REQUEST FOR INFORMATION DATE: August 03, 2016 **NO.:** RFI-232

Project Name: 15051-Webster University Interdisciplinary Science Building Project No.: 15051

Subject: Water Heater Flue

DOMESTIC WATER HEATER INTAKE/EXHAUST (NOT TO SCALE)

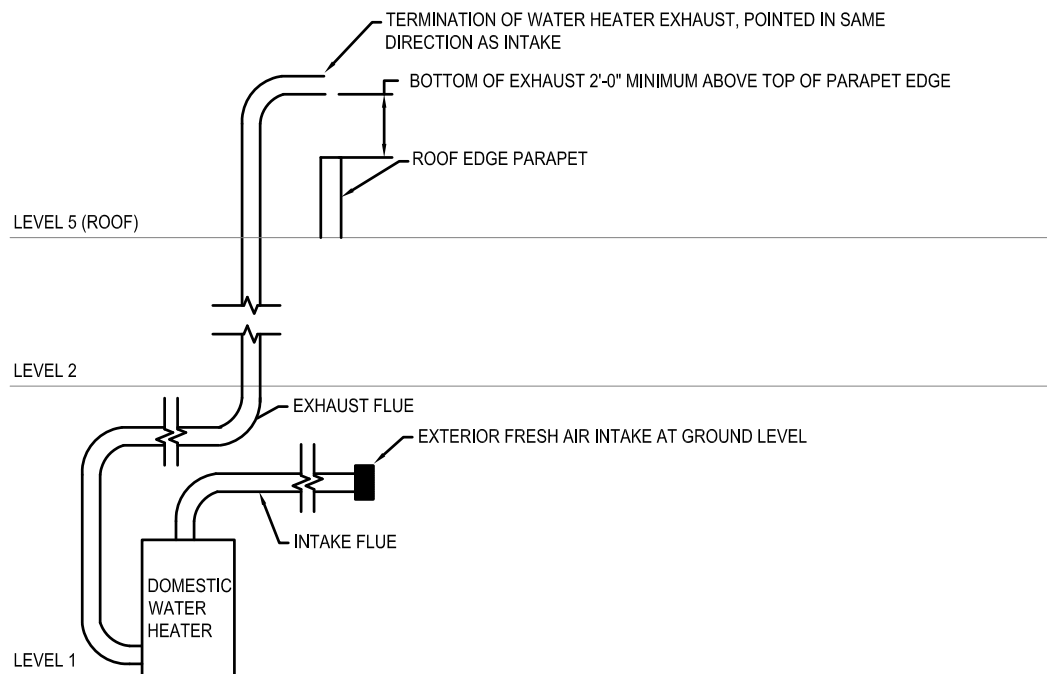
Concerning the gas-fired domestic water heater intake/flue – The Ruud water heater rep (Mark Carnoali) reviewed the water heater intake/exhaust design with the Tao mechanical engineer. The agreement was that as long as the water heater flue terminates at the roof elevation as noted on the attached sketch, it should help reduce the potential for pressurization issues with the fresh air intake located at ground level.

The venting limitations discussed with Ruud is unacceptable to the architectural aesthetics of the building. We are rejecting the Ruud water heaters based on this venting issue and recommending providing an approved/listed alternate manufacturer that does not have these venting limitations, i.e. Lochinvar Shield.
